Attachment 1 – Pictures of Inspection Findings

AD 2006-15-15

MD80-29A070 Rev 2

Aux Hydraulic Pump
Power Cable Route

Attachment 1 – Pictures of Inspection Findings: Area 1

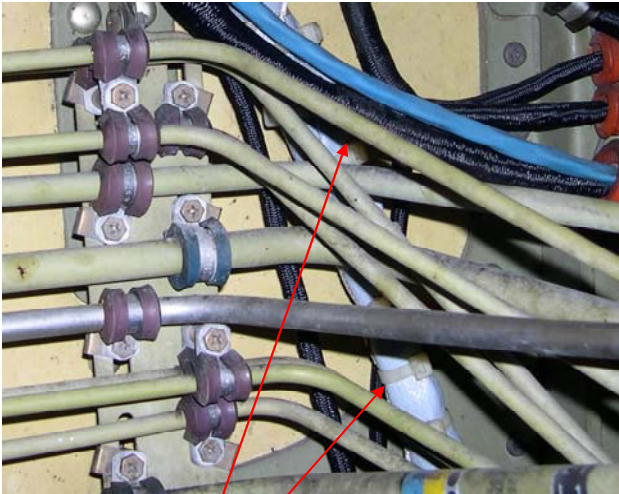
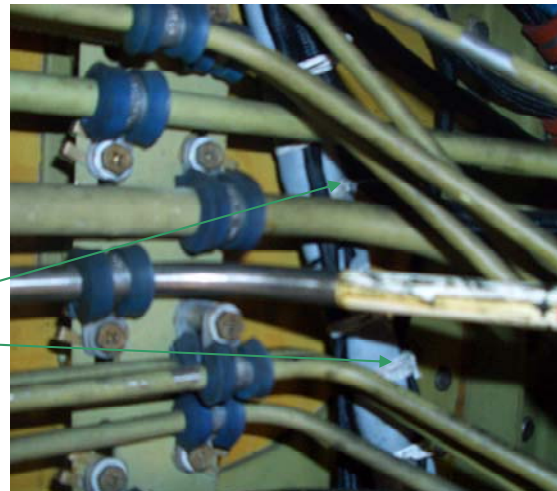
Incorrect - Use of Nylon Tie Wraps

**Correct – Use of tie tape
DMS 2089 per Service
Bulletin**

Attachment 1 – Pictures of Inspection Findings: Area 1

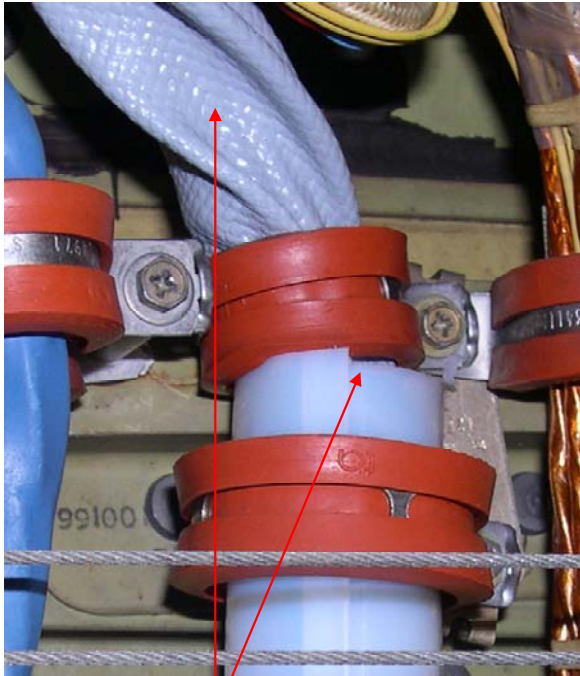
Incorrect – Snap tube installed too long. No tie tape used

Correct – Snap tube installed per Service Bulletin with tie tape

Attachment 1 – Pictures of Inspection Findings: Area 2

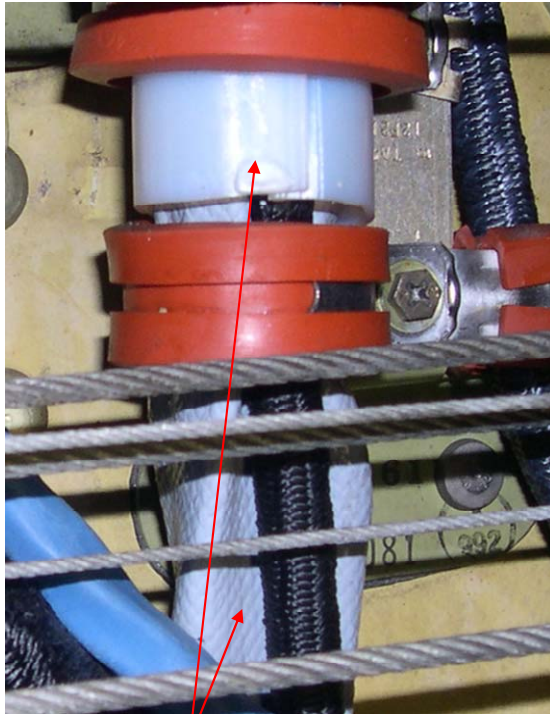
Incorrect – Clamp not secured

Correct – Clamps secured to mount

Attachment 1 – Pictures of Inspection Findings: Area 2

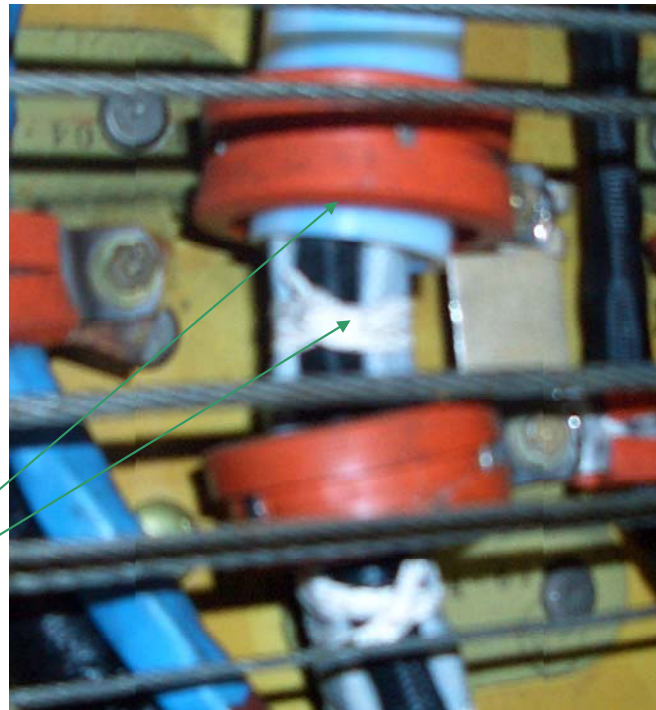
Incorrect – Snap tube too Long and no tie tape

Correct – Snap tube installed per Service Bulletin with tie tape

Attachment 1 – Pictures of Inspection Findings: Area 2

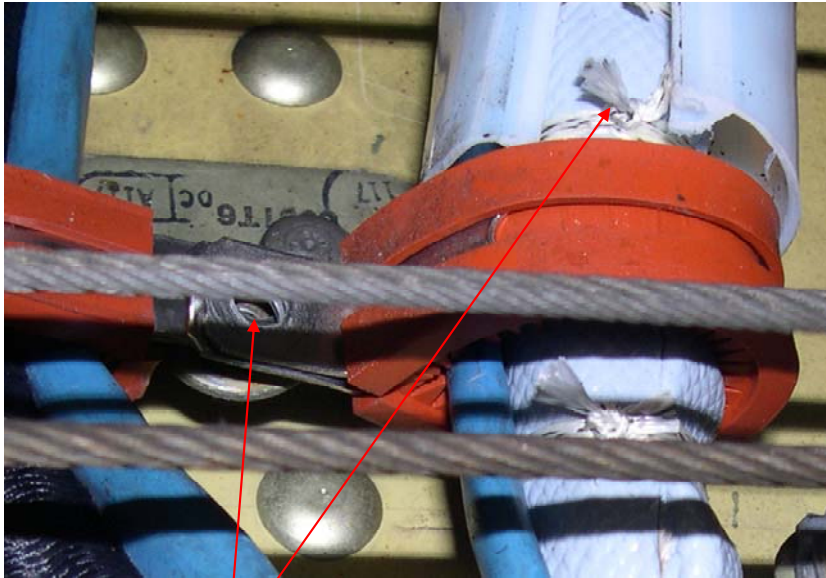
Incorrect – Clamp not installed and snap tube open and not installed in clamp

Correct – Installed correctly per Service Bulletin

Attachment 1 – Pictures of Inspection Findings: Area 3

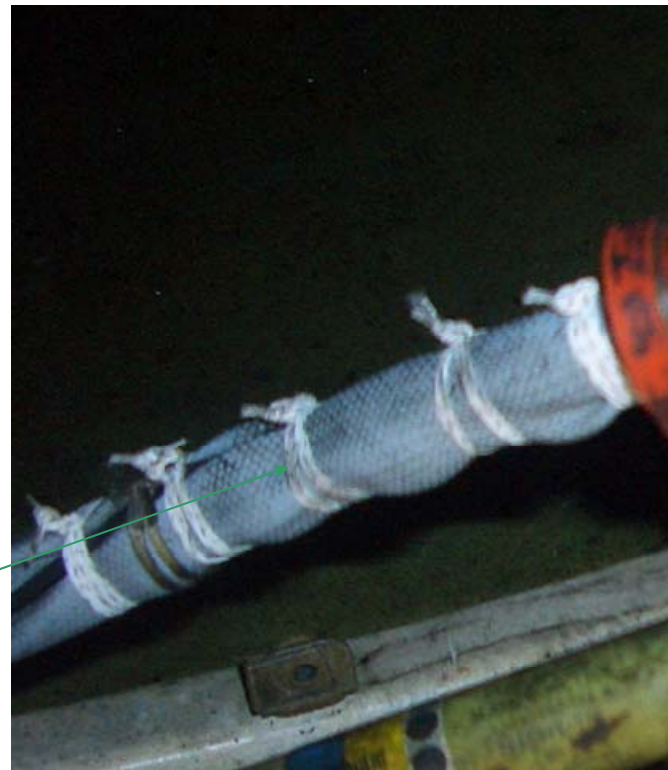
Incorrect – No tie tape installed

Correct – installed tie tape per Service Bulletin

Attachment 1 – Pictures of Inspection Findings: Area 4

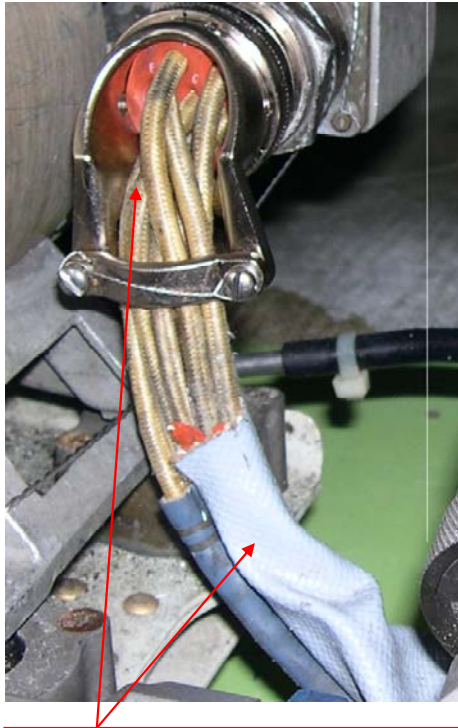
**Incorrect – No wrap on
Back shell of connector
and no tie tape**

**Correct – Wrap on
connector and tie tape**
